HERITAGE IMPACT ASSESSMENT OF 441 ECHO DRIVE, OTTAWA

MAY 7, 2026 JUXTA
PROJECT NO. 2541

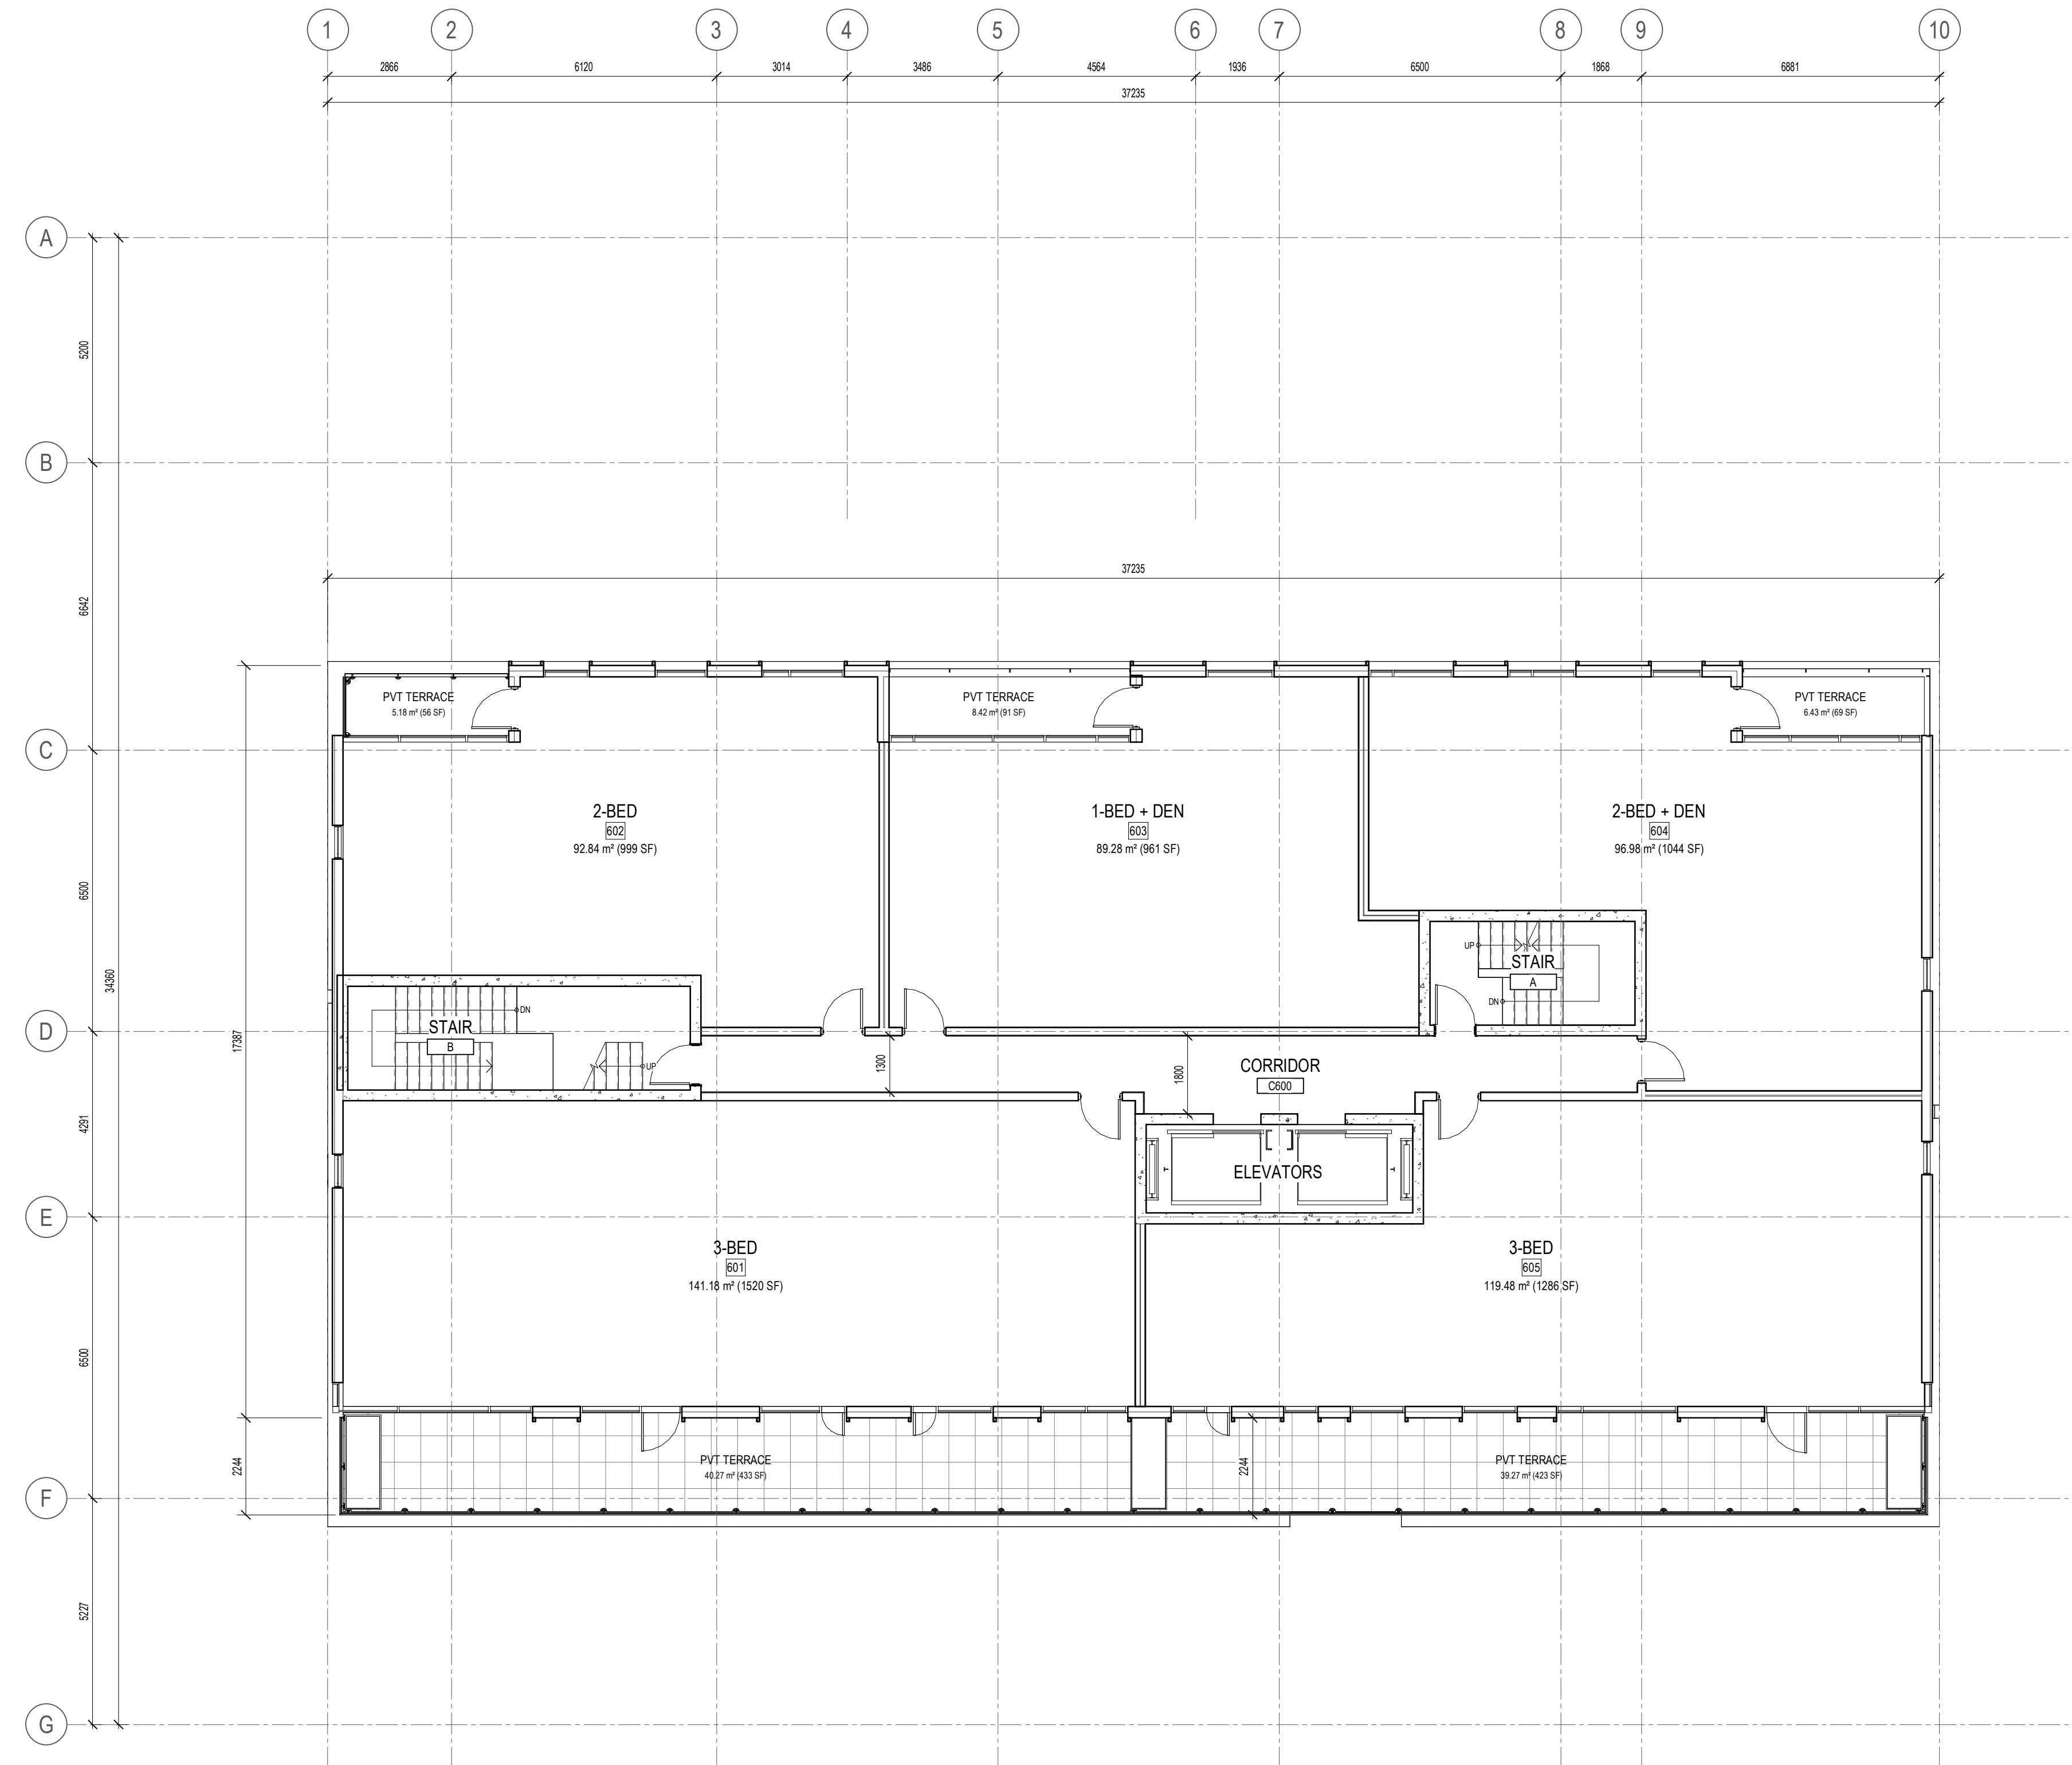
2. Drawings are not to be scaled. The Contractor is responsible for checking and verifying all levels and dimensions and shall report all discrepancies to the Architect and obtain clarification prior to commencing work.

3. Upon notice in writing, the Architect will provide written graphic clarification or supplementary information regarding the intent of the Contract Documents.

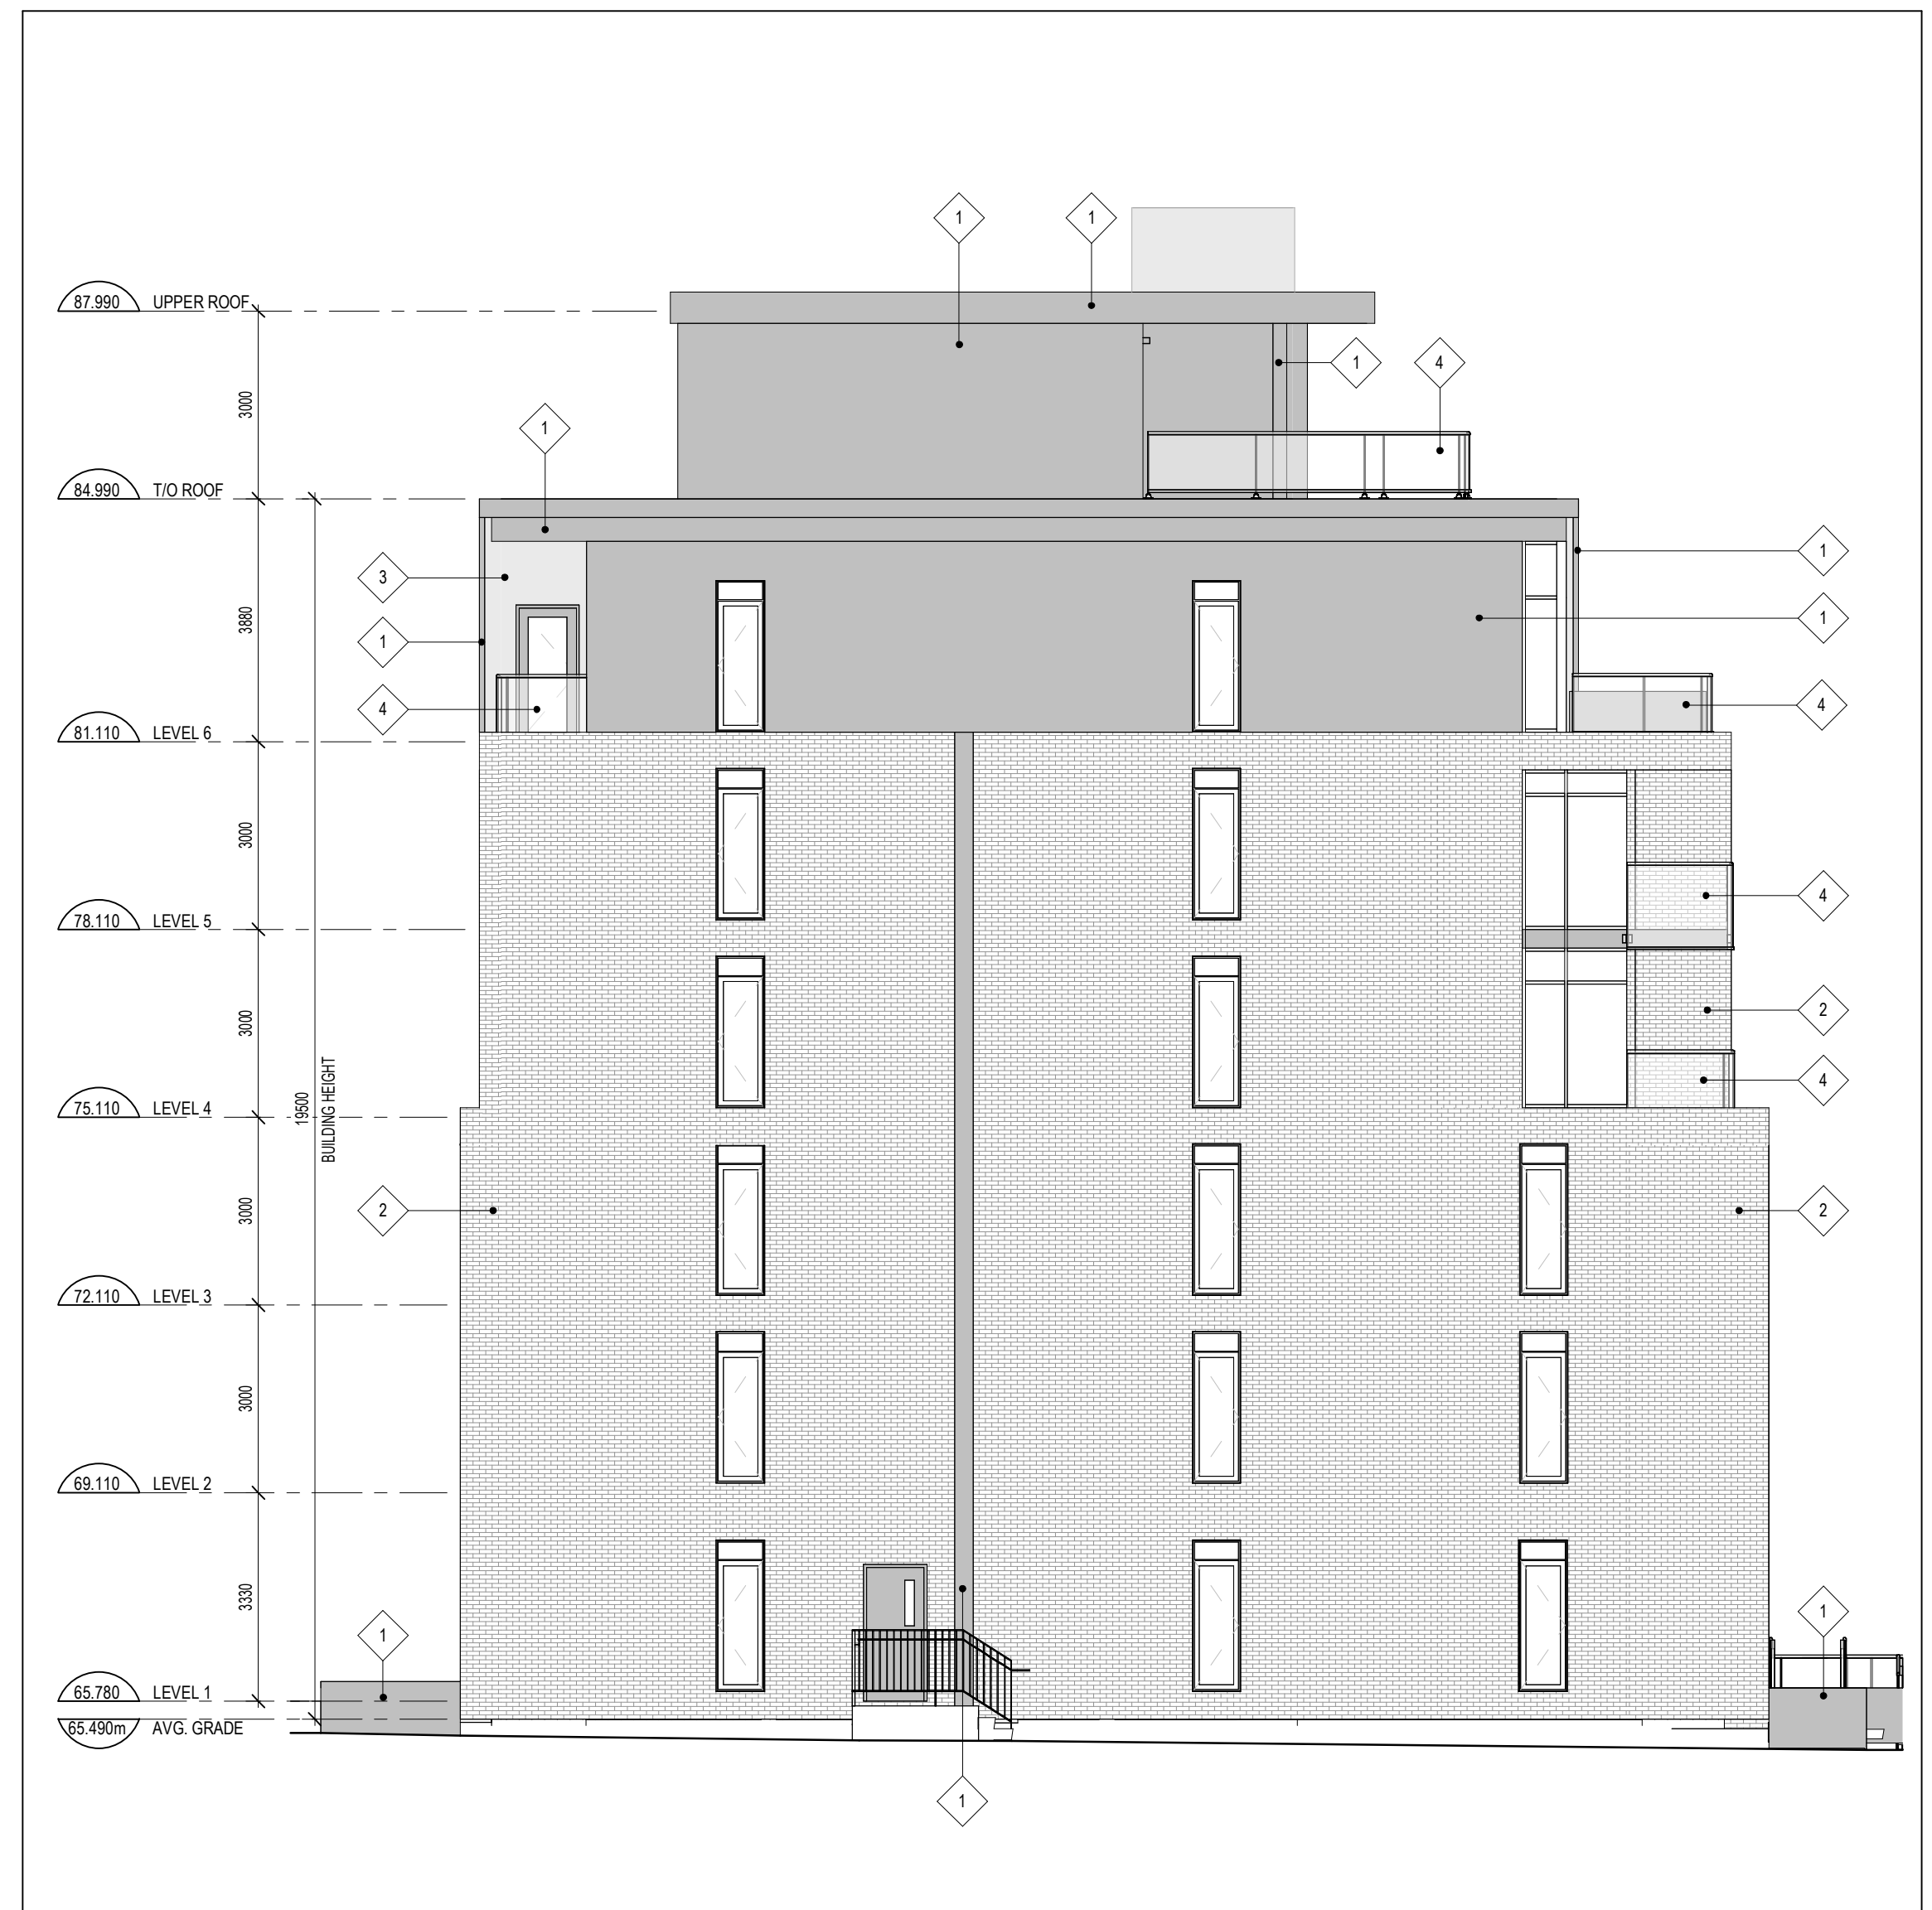
2. Drawings are not to be scaled. The Contractor is responsible for checking and verifying all levels and dimensions and shall report all discrepancies to the Architect and obtain clarification prior to commencing work.

3. Upon notice in writing, the Architect will provide written graphic clarification or supplementary information regarding the intent of the Contract Documents.

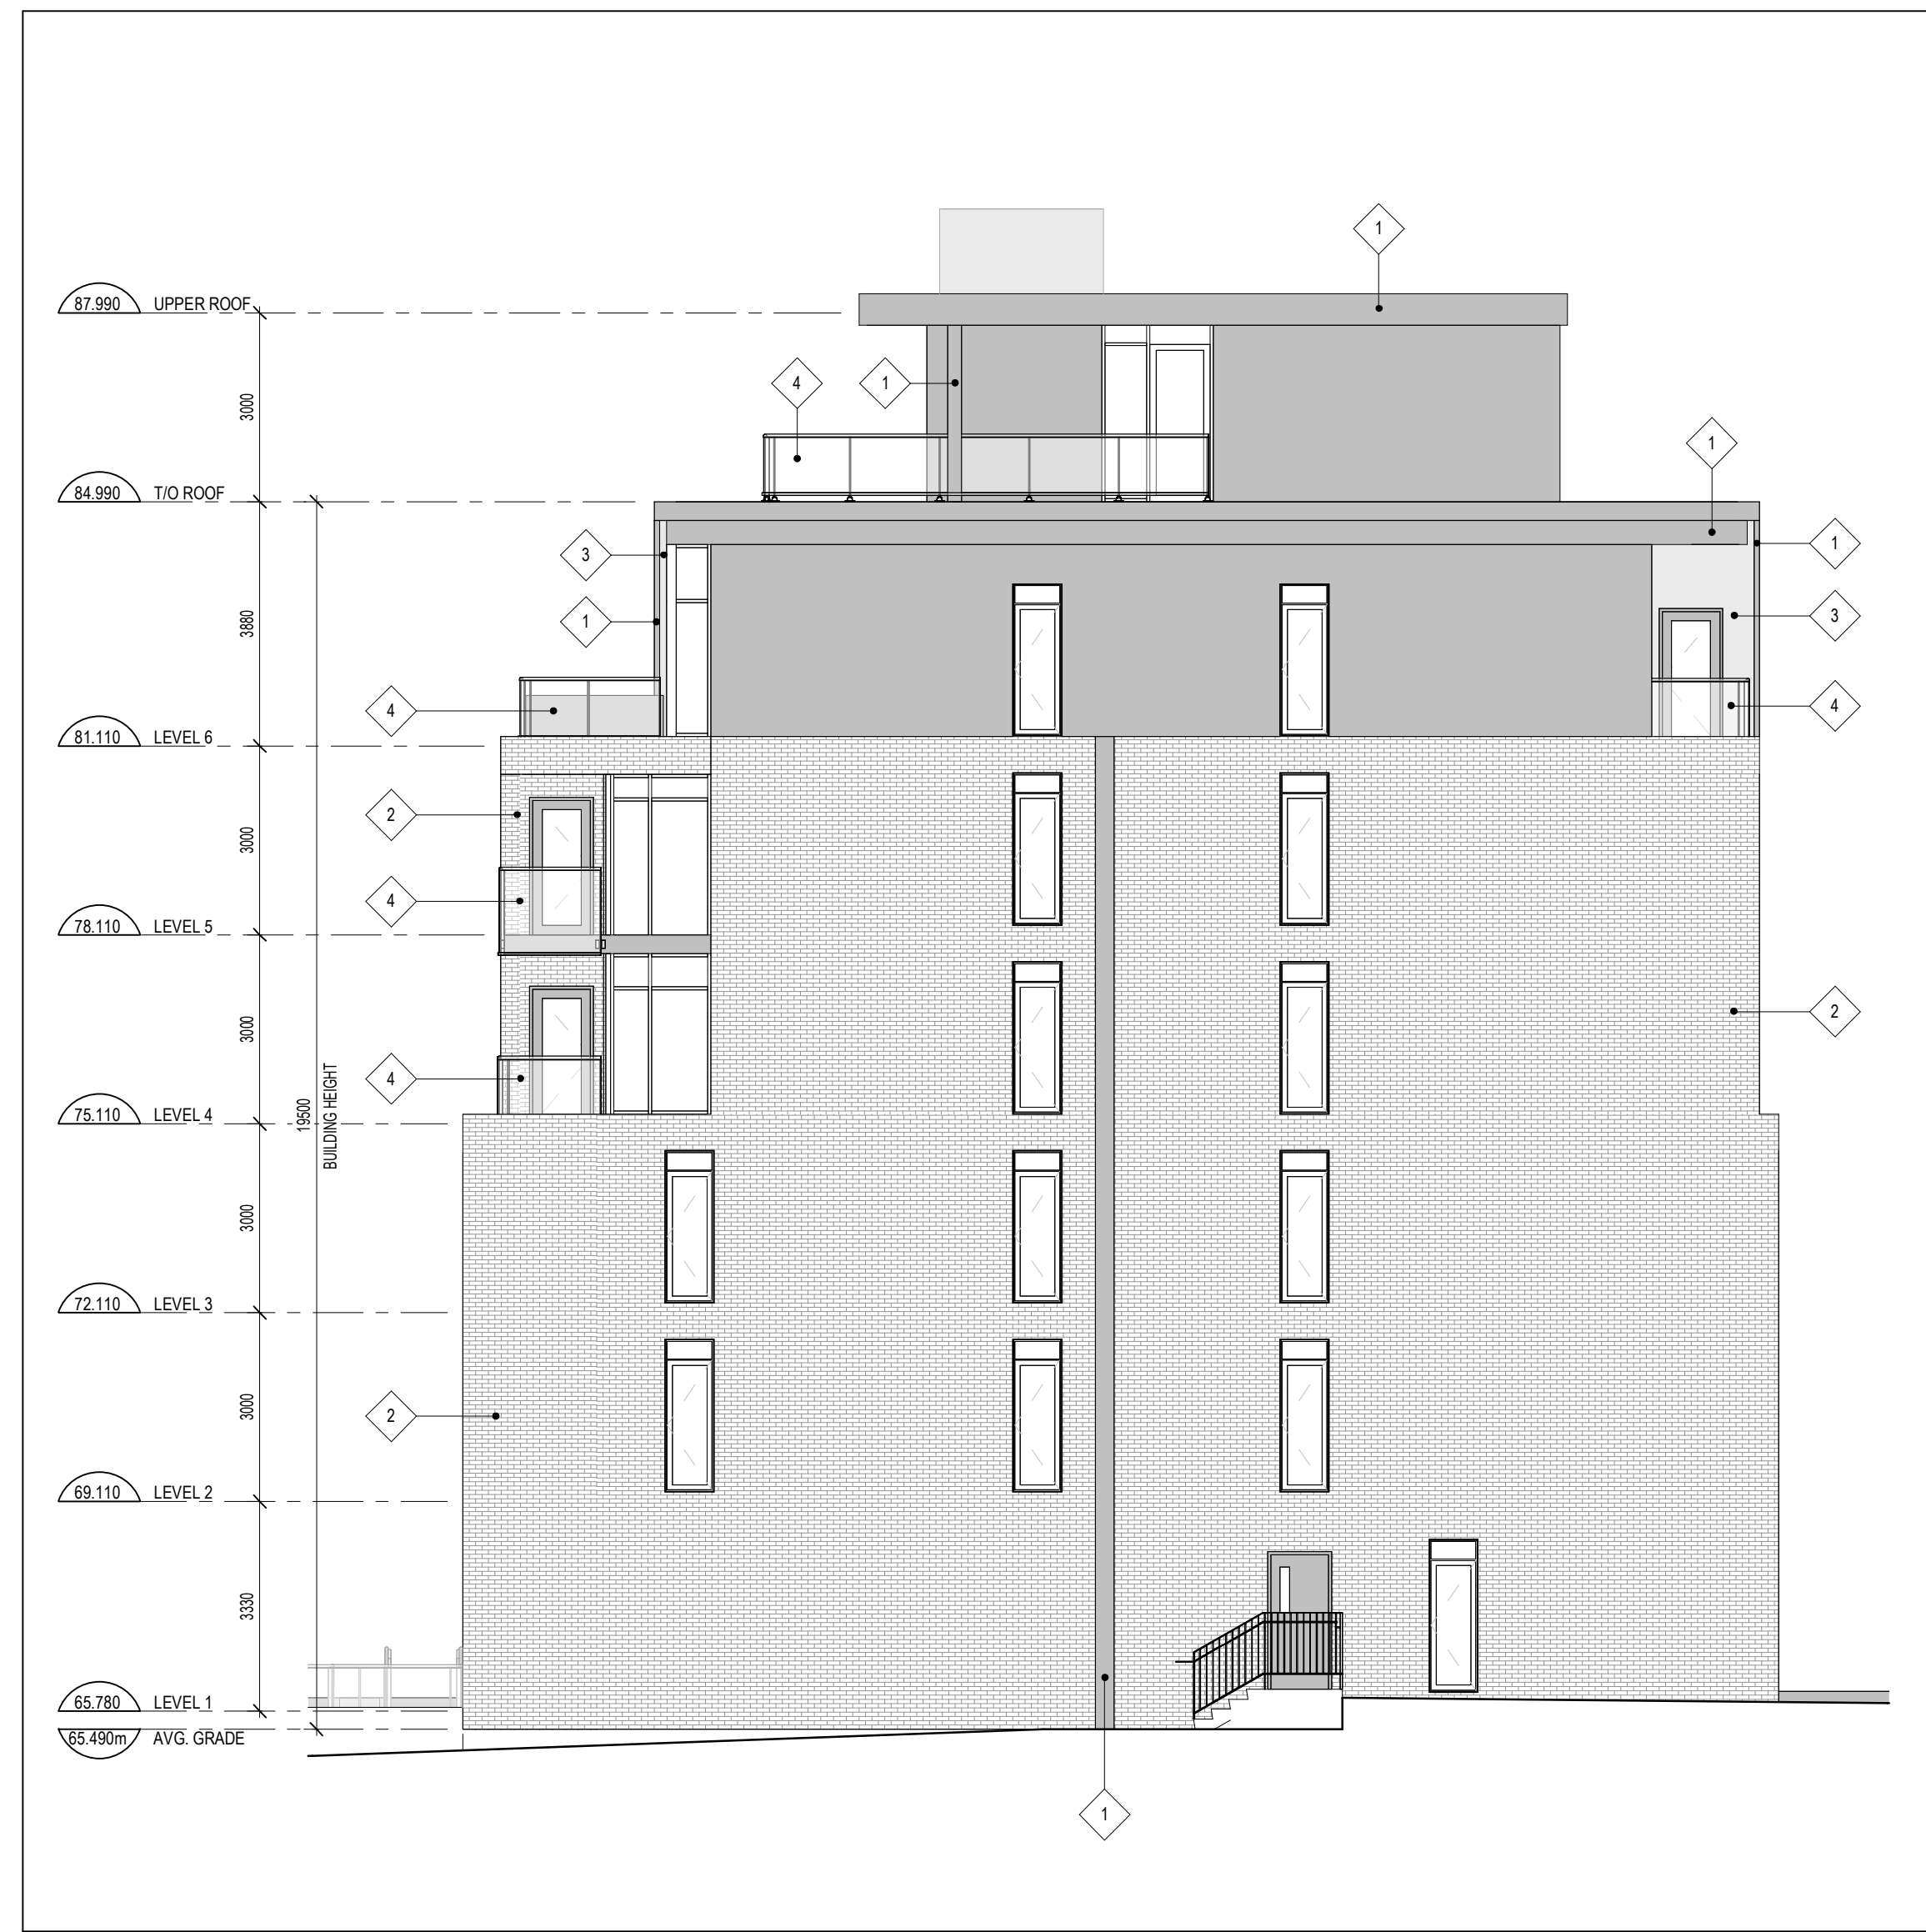
2. Drawings are not to be scaled. The Contractor is responsible for checking and verifying all levels and dimensions and shall report all discrepancies to the Architect and obtain clarification prior to commencing work.

3. Upon notice in writing, the Architect will provide written clarification or supplementary information regarding the intent of the Contract Documents.
